Access Compliance Report

Public Rights-of-Way

(Curb Ramps)

Intersection ID: 8551	Main Street: S_HOSKINS_RD	Cross Street: GLENWOOD_DR	Location:	E
ADA ID: E6783756609E	Ramp Type: Perp	Initial Pass/Fail: Fail	Overall Compliance: No	Severity Score: 8.75
Codes/Mitigation Info/Possible Solution		Field Measurements/Component Compliance

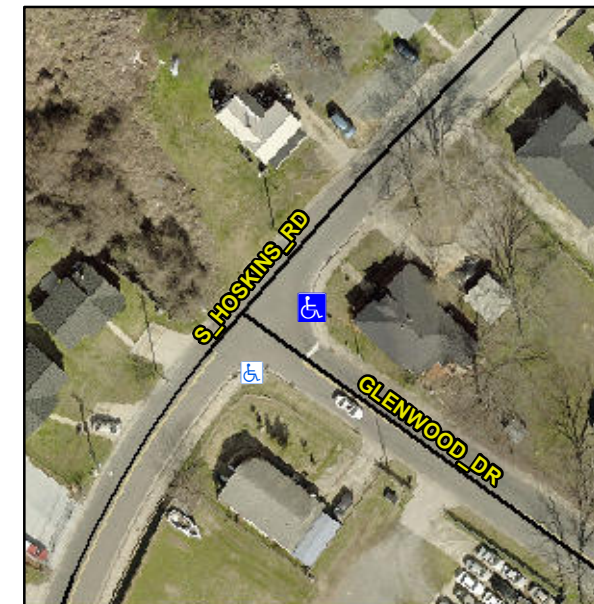
Remove & Replace Entire Ramp.

Not Found, R304.5.1

Compliance	Description	Data	Compliance	Description	Data
N/A	Ramp Length (in)	25.0	Yes	Ramp Slope (%)	7.4
No	Ramp Width (in)	47.5	Yes	Ramp XSlope (%)	1.6
N/A	Flare Type LT	N/A	N/A	Flare Type RT	N/A
N/A	Flare Slope LT (%)	N/A	N/A	Flare Slope RT (%)	N/A
N/A	Flare Traversable LT?	N/A	N/A	Flare Traversable RT?	N/A
N/A	Landing Length (in)	N/A	N/A	DWS Provided?	N/A
N/A	Landing Width (in)	N/A	N/A	DWS Contrast?	N/A
N/A	Landing Slope (%)	N/A	N/A	DWS Length (in)	N/A
N/A	Landing X Slope (%)	N/A	N/A	DWS Full Width?	N/A
N/A	Landing Curb? (Y/N)	N/A	N/A	DWS Offset (in)	N/A
N/A	Shared Landing?	N/A			
N/A	Gutter Ponding?	N/A	N/A	Gutter Slope (%)	N/A
N/A	Gutter Lip Ht (in)	N/A	N/A	Gutter X Slope (%)	N/A
N/A	Painted X Walk1?	No	N/A	Painted X Walk2?	N/A
	X Walk 1 Direction	To SW		X Walk 2 Direction	N/A
N/A	X Walk 1 Width (in)	N/A	N/A	X Walk 2 Width (in)	N/A
	X Walk 1 Slope (%)	1.4		X Walk 2 Slope (%)	N/A
	X Walk 1 X Slope (%)	2.0		X Walk 2 X Slope (%)	N/A
